RE: MINOR CHANGE APPLICATION FOR DEVELOPMENT PERMIT FOR RECONFIGURING A LOT (1 INTO 14 LOTS) AND NEW ROAD (A006155822) AT 196 GRAHAM ROAD, BRIDGEMAN DOWNS, QLD, 4035 DESCRIBED AS LOT 2 ON RP70194

1.1. Requested Change

FIGURE 2: APPROVED PLAN

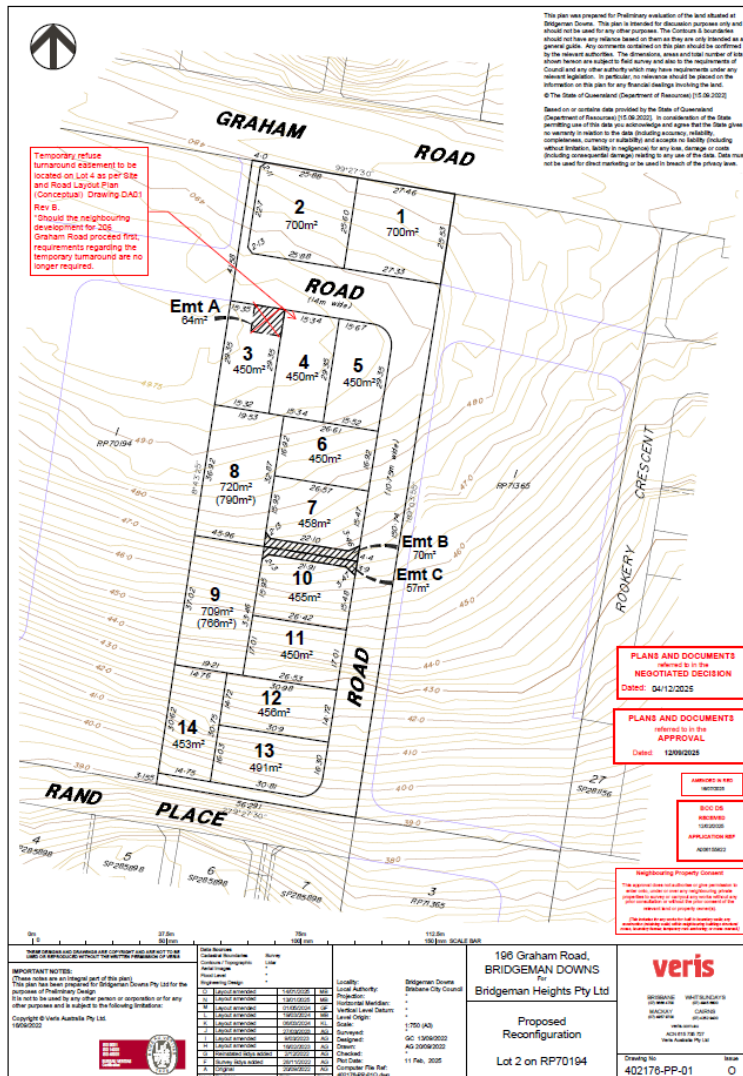
The 700m² lots fronting Graham Road at 196 Graham Road were specifically designed to reduce the perceived density and provide a low-density residential aspect from Graham Road commensurate with Lot 15 and 16 SP317388 – **in accordance with Council's requirements as proposed in the aforementioned IR** (i.e., "in accordance with the prevailing lot sizes within the vicinity").

The applicant seeks to change the approved Reconfiguration Plan (Drawing No 402176-PP-01 - Issue O) to allow for the creation of an additional (1) lot. The proposal is to subdivide the approved Lot 1 and Lot 2 into three equal size lots (with an area of 467m² and frontages of 18.23m), as shown below.

FIGURE 3: NEIGHBOURING DEVELOPMENT FRONTING GRAHAM ROAD

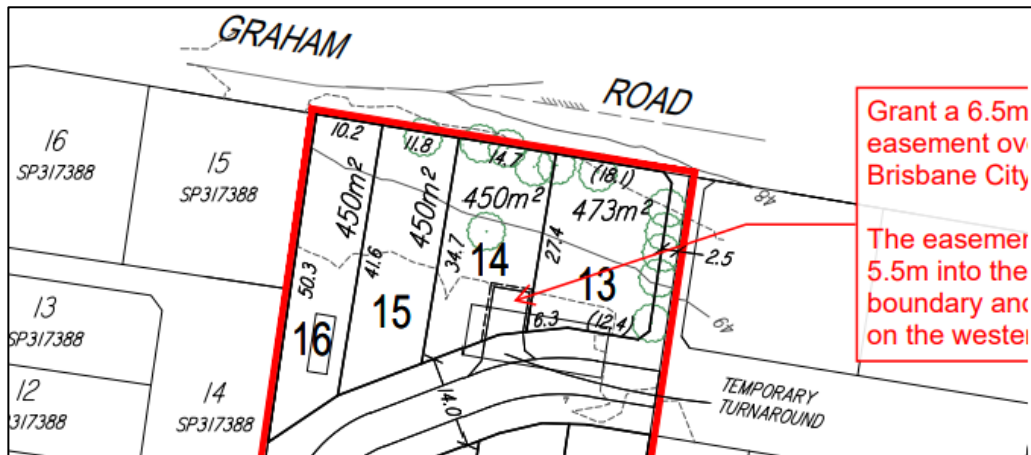
The recently approved development at 206 Graham Road, Bridgeman Downs (A006724928) provides three lots of 450m2 and one of 473m2 with frontages of 10.2m, 11.8m, 14.7m and 18.1m respectively – clearly demonstrating a shift in Council position regarding a desired low density residential aspect to Graham Road.
